TECHNICAL SERVICE BULLETIN

REF.: TRANSMISSION & CLUTCH
NO.: TC95-010
DATE: NOVEMBER 30, 1995
MODEL: COR & CEL

C40, C5# TRANSAXLE RING GEAR SET BOLT

ILLUSTRATION:

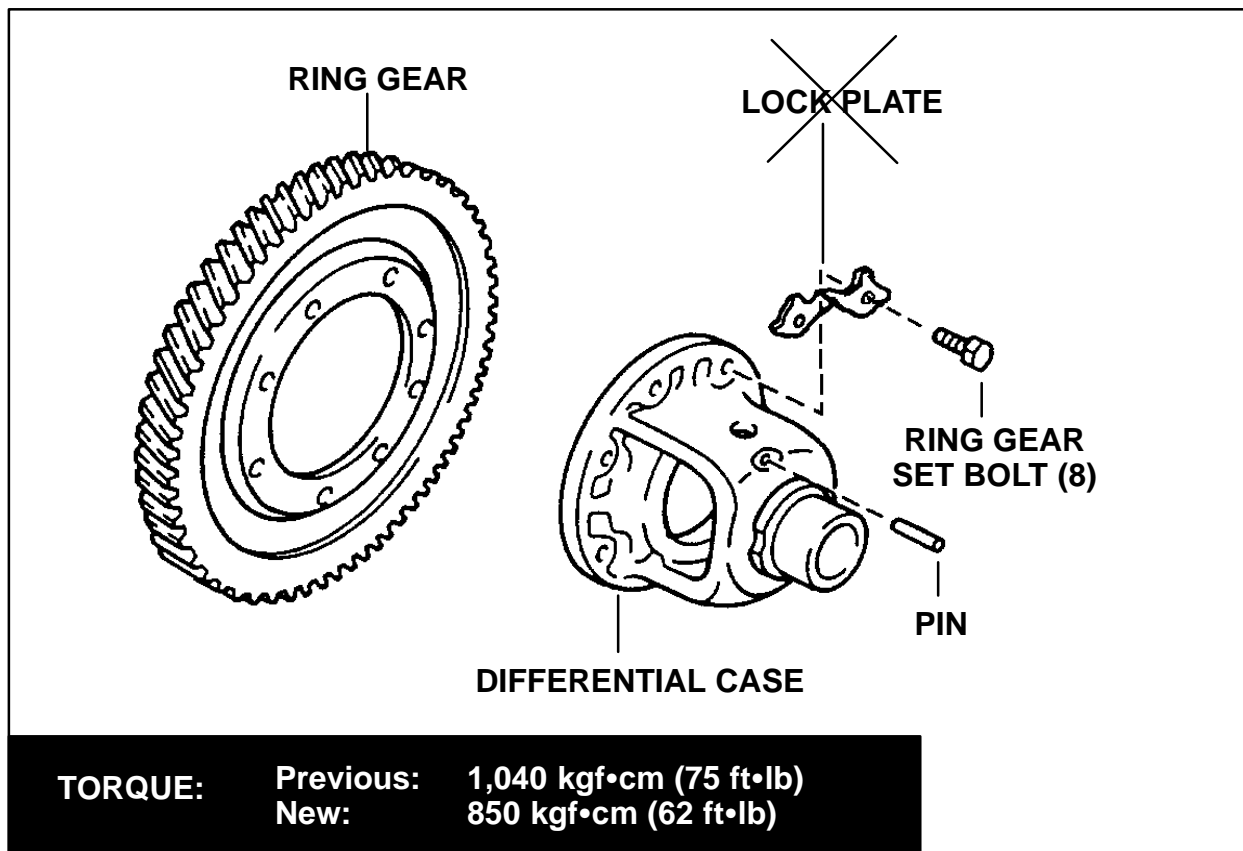
Due to a transaxle production change on the Corolla and Celica models, differential lock plates have been discontinued. Torque specification for the ring gear set bolts has also been changed as indicated.

Transaxle Serial Number: From: Z50100001~
From: X50100021~
